Response to DPE Request for Additional Information – 8 April 2022

Snowy 2.0 Transmission Connection Project

Response to Request for Additional Information– DPE, July 2022

Figure 2: Concept steel lattice tower (base case) and steel monopole design

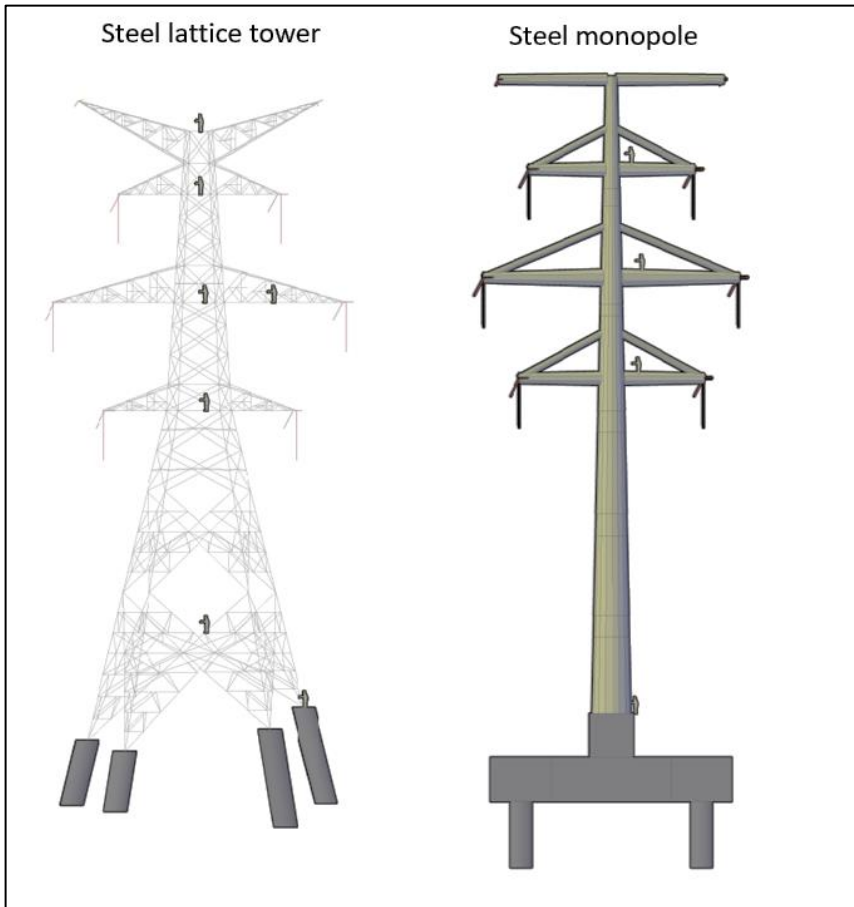
An indicative concept design for the steel monopole for the Snowy 2.0 connection compared to the base case steel lattice tower is shown in Figure 2. Furthermore, photomontages have been prepared to show the steel monopole design based on the revised concept design at viewpoint 12, which is a sensitive receiver location at Lobs Hole. One key photomontage is shown in Figure 3 with the full suite provided in Appendix B.

The load analysis indicated that the maximum base width required for steel monopole would need to be in the order of approximately 3.7 metres in diameter. The middle cross arm for the steel monopole design would need to extend approximately 10 metres each side of the steel pole. These structure widths and cross arm lengths are significant and are comparable to a medium sized wind turbine. It could be possible to reduce the size/width of the steel monopoles; however, this would involve the inclusion of additional structures to reduce the span width. The inclusion of additional structures would result in further revegetation clearing along the easement and additional clearing for access tracks. As such, reducing the size of the steel monopoles through the establishment of more structures along the approximate 9-kilometre-long connection route was not considered as it would not align with the project objectives in minimising vegetation clearing and habitat loss.

Photograph 10: Bridge crossing over Paddys River, Tooma Road (Council Road)

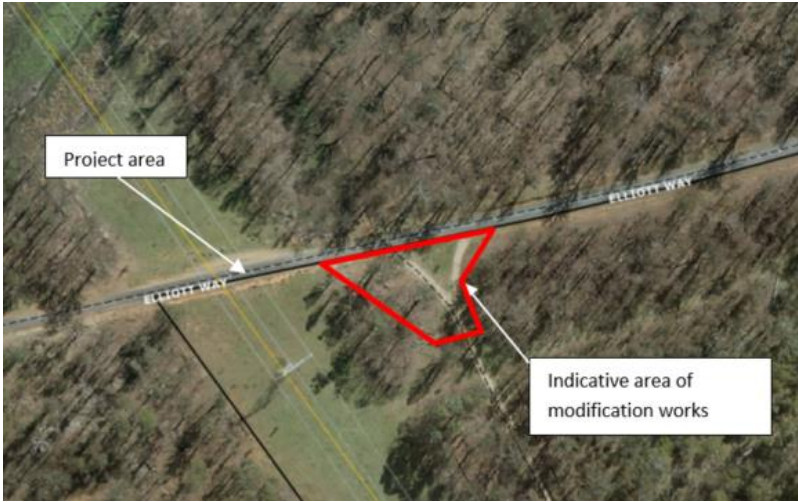
The initial bridge assessment only included an assessment of bridge crossings along the State Road network, under the jurisdiction of Transport for NSW only and did not include the network of Council roads from Tumbarumba to the proposed Maragle substation site. This section of the route would traverse two bridge crossings, south east of Tumbarumba: Burra Creek and Paddys River along Tooma Road (refer to Figure 4 and Photograph 9 and Photograph 10.

Transgrid has commenced consultation with Snowy Valleys Council and is in the process of obtaining the relevant design/engineering plans to carry out the loading assessment for the haulage of the high mass substation equipment. Given the age of these bridges, designs have not been digitised. As such, delays have been experienced in undertaking the necessary bridge assessments due to the availability of the hard copy of the bridge designs. At the time of preparing this response, the designs for one of the bridge crossings have still not been located by Council. Notwithstanding this, given both bridges are comprised of two lanes (one in each direction), no widening of the bridge is required. Furthermore, any upgrade/reinforcement works is expected to be limited to the existing bridge structure such the placement of temporary or permanent bracing and/or supports. Any piling or reinforcement of bridge columns that may be required to uprate the bridges would be carried out in a manner that would not affect stream flows or fish passage. Furthermore, appropriate sediment controls (such as sediment curtains) would be used to control the dispersal of sediment, should any in-stream works be required. Further information would be provided to DPE once the loading assessments of the two bridges has been completed.

Figure 5: Substation layout showing components where a GIS solution could not be found

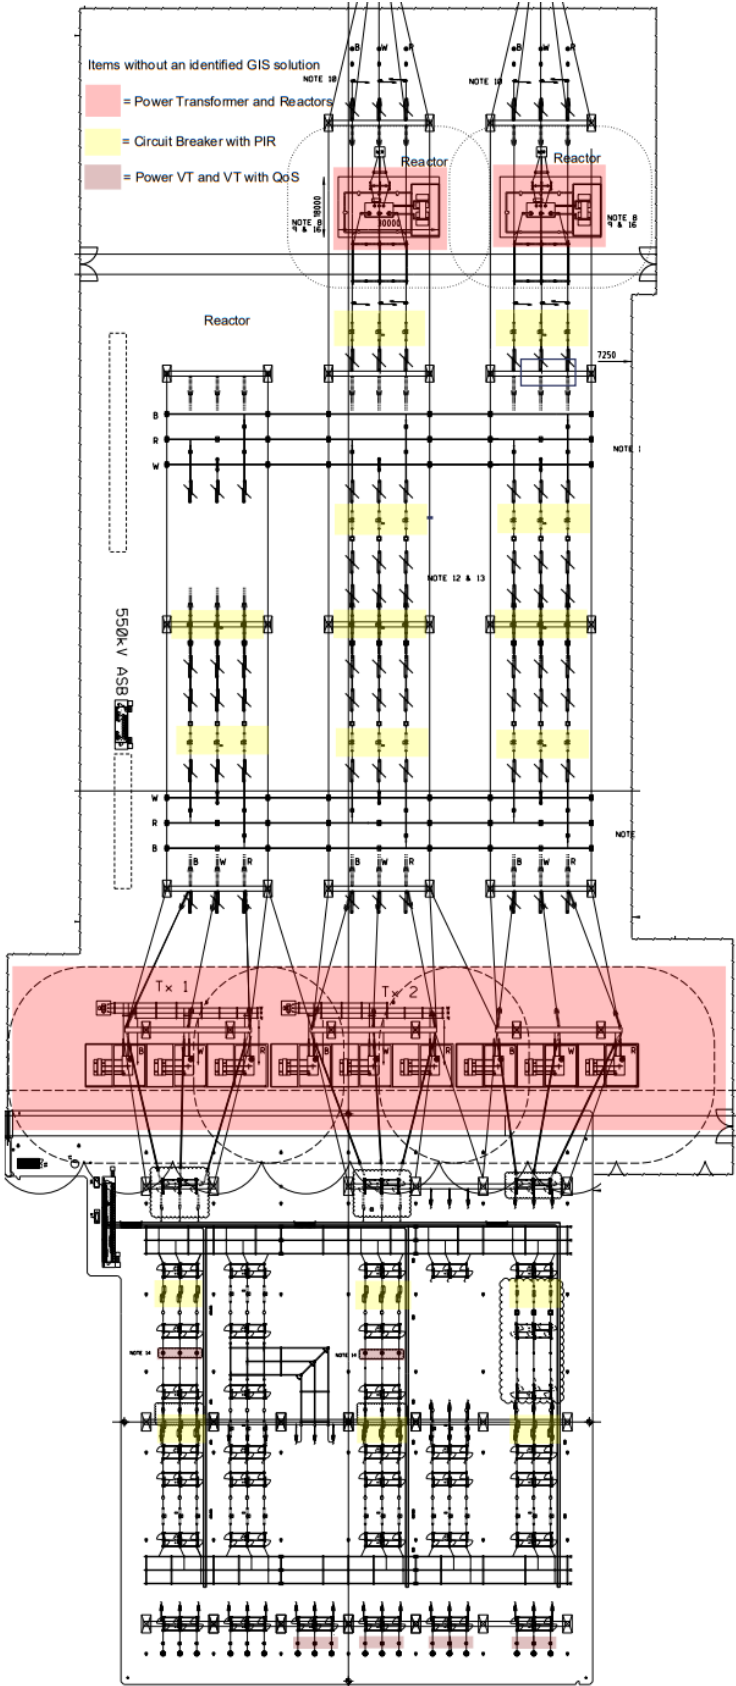
This would result in the transformers, reactors, 500 kV Circuit Breakers, 330 kV transformer switching circuit breakers, Power VT's and Quality of Supply CVT's needing to be AIS. If the remaining High Voltage plant was then installed in GIS, the reduction in site footprint afforded by the GIS would be minimal and the ad hoc nature of the site along with the complicated AIS to GIS interfaces would likely offset any potential reduction in site footprint. The substation layout which shows all high voltage equipment where a GIS solution could not be found is shown in Figure 5.

Further investigation for the potential to use indoor GIS at the proposed substation was carried out by Transgrid. The following limitations associated with the use of indoor GIS at the proposed substation from a technical and network planning perspective include the following:

- System planning studies require the power transformers to have an overload capacity of 600MVA (single phase). Further, system planning studies require a basic insulation level (BIL)/Lightning impulse withstand of 1550kV. Transgrid has not identified a Gas Insulated Transformer (GIT) supplier that can meet these specifications. As such, outdoor AIS power transformers are required.

- System planning studies require a BIL/Lightning impulse withstand of 1550 kilovoltage peak. Transgrid has not identified a Gas Insulated Reactor (GIR) supplier that can meet these specifications. As such, outdoor AIS reactors are required.

Appendix B Photomontage at viewpoint 12

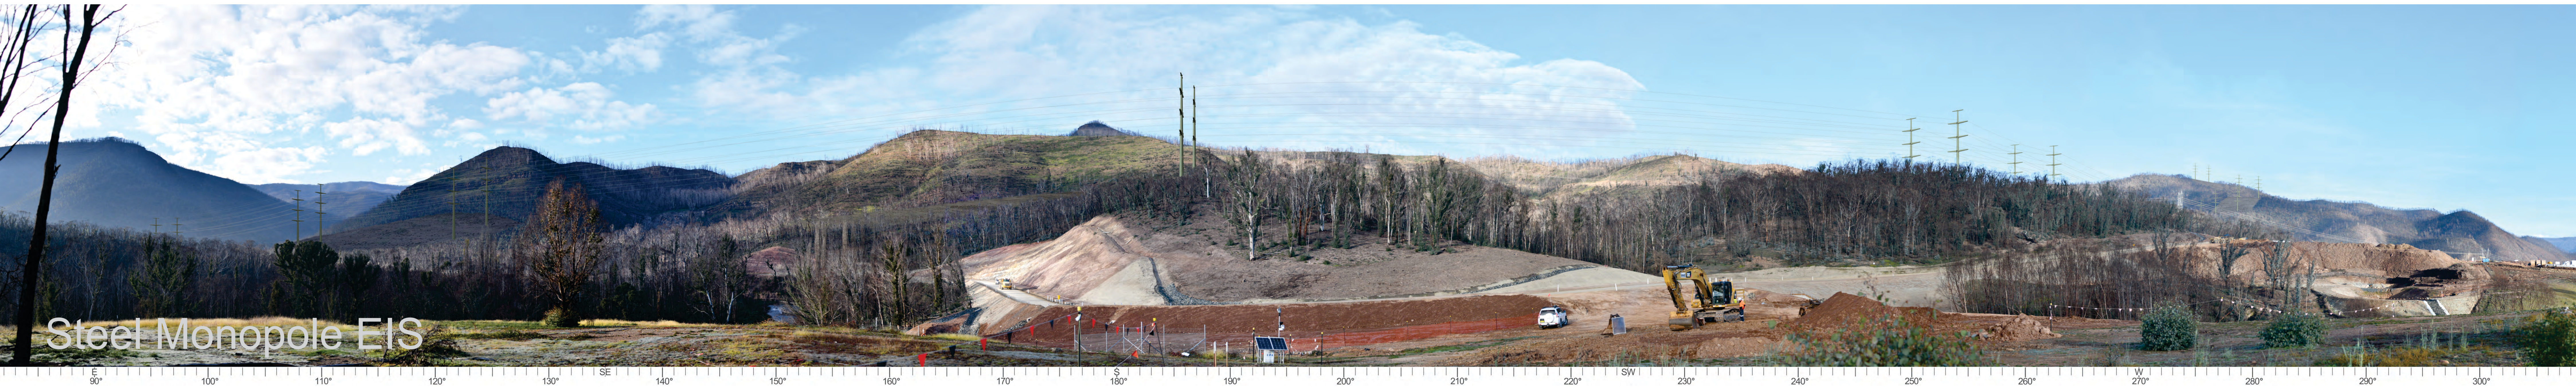
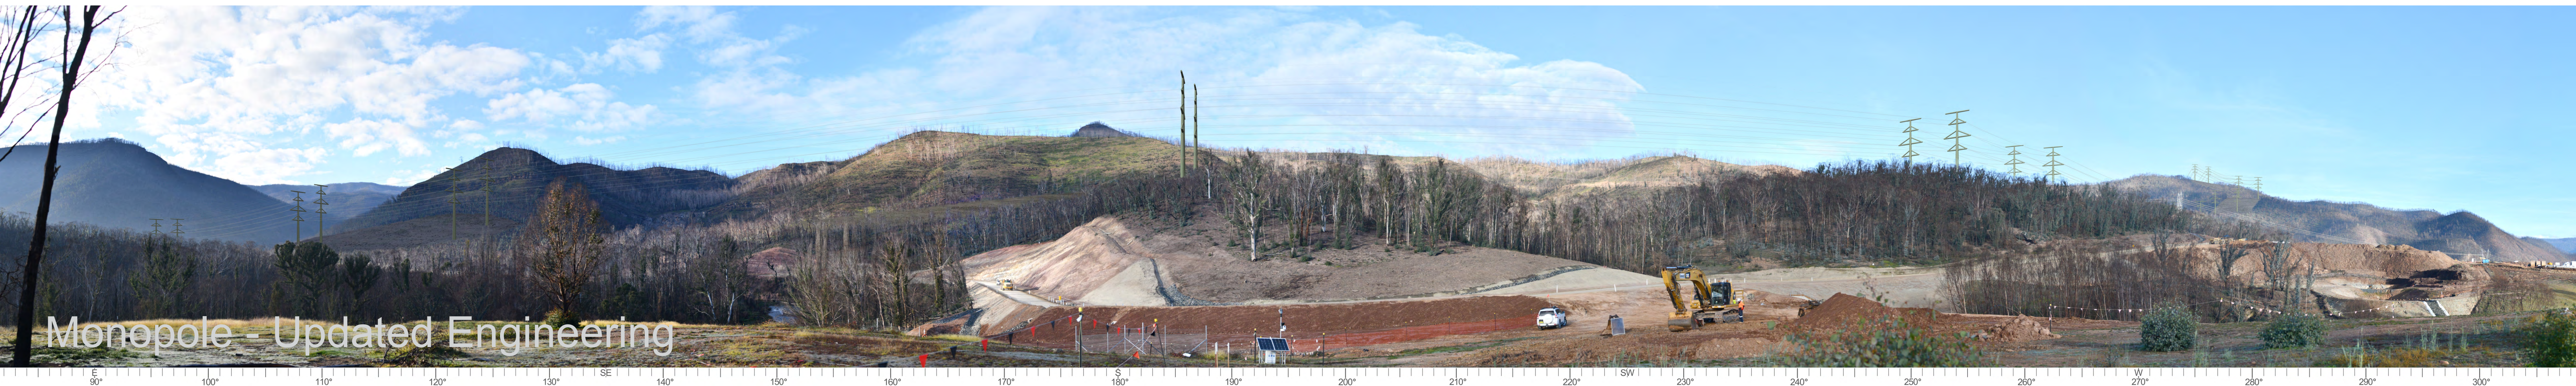
Figure 3: Photomontage at viewpoint 12 showing steel monopole as presented in the Supplementary LC VIA and the updated concept design
